COMMUNITY BOARD FEEDBACK PACKAGE

Business Name: Mr. Biggs Bar and Grill

Cafe Address: 596 10 AVENUE, NEW YORK, NY, 10036

Application Number: 20240803010152

10th Avenue Frontage

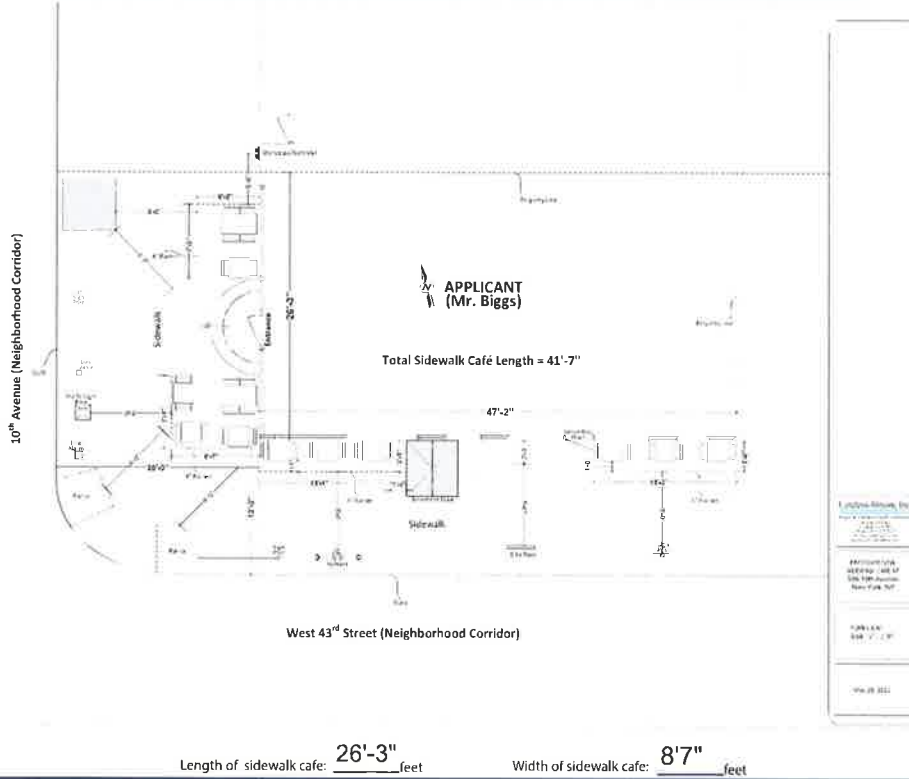
The proposed Site Plan does not provide for the required 10 foot clear path on the Tenth Avenue side of the sidewalk cafe.

The proposed Site Plan does not provide for the required 10 foot clear path on the Tenth Avenue side of the sidewalk cafe.

MCB4 recommends that the site plan be modified to provide for the required 10 foot clear path by removing two tables with two chairs each from the Tenth Avenue side of the sidewalk cafe and combining the two-top and four-top tables into one table with six chairs. The applicant has agreed to these modifications and provided the attached Revised Site Plan.
